Access Compliance Report

Public Rights-of-Way

Intersection ID: 30233	Main Street: BELLS_KNOX_RD	Cross Street: LEECREST_DR	Location:	N
ADA ID: 328721B591B2	Ramp Type: PerpDiag	Initial Pass/Fail: Fail	Overall Compliance: No	Severity Score: 25

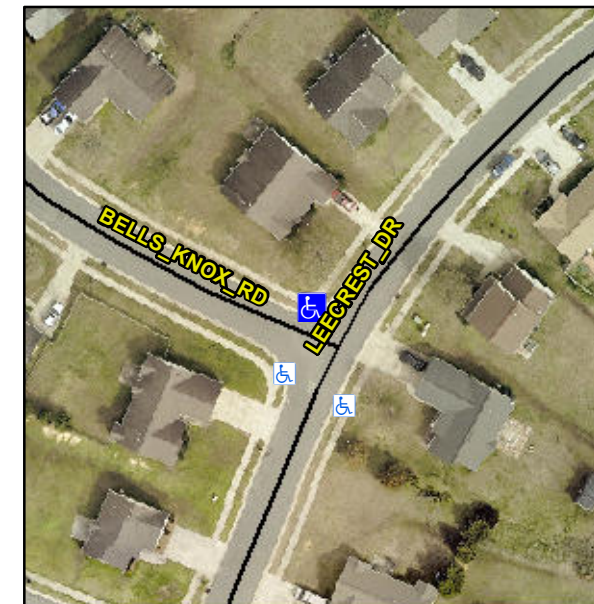
R304.5.3

Compliance	Description	Data	Compliance	Description	Data
N/A	Ramp Length (in)	36.0	Yes	Ramp Slope (%)	6.3
Yes	Ramp Width (in)	48.0	No	Ramp XSlope (%)	8.6
N/A	Flare Type LT	N/A	N/A	Flare Type RT	N/A
N/A	Flare Slope LT (%)	N/A	N/A	Flare Slope RT (%)	N/A
N/A	Flare Traversable LT?	N/A	N/A	Flare Traversable RT?	N/A
N/A	Landing Length (in)	N/A	N/A	DWS Provided?	N/A
N/A	Landing Width (in)	N/A	N/A	DWS Contrast?	N/A
N/A	Landing Slope (%)	N/A	N/A	DWS Length (in)	N/A
N/A	Landing X Slope (%)	N/A	N/A	DWS Full Width?	N/A
N/A	Landing Curb? (Y/N)	N/A	N/A	DWS Offset (in)	N/A
N/A	Shared Landing?	N/A			
N/A	Gutter Ponding?	N/A	N/A	Gutter Slope (%)	N/A
N/A	Gutter Lip Ht (in)	N/A	N/A	Gutter X Slope (%)	N/A
N/A	Painted X Walk1?	No	N/A	Painted X Walk2?	No
	X Walk 1 Direction	To SW		X Walk 2 Direction	To SE
N/A	X Walk 1 Width (in)	N/A	N/A	X Walk 2 Width (in)	N/A
	X Walk 1 Slope (%)	2.7		X Walk 2 Slope (%)	4.2
	X Walk 1 X Slope (%)	6.2		X Walk 2 X Slope (%)	6.7

Remove & Replace Curb Ramp With Two New Directional Ramps or Equivalent.
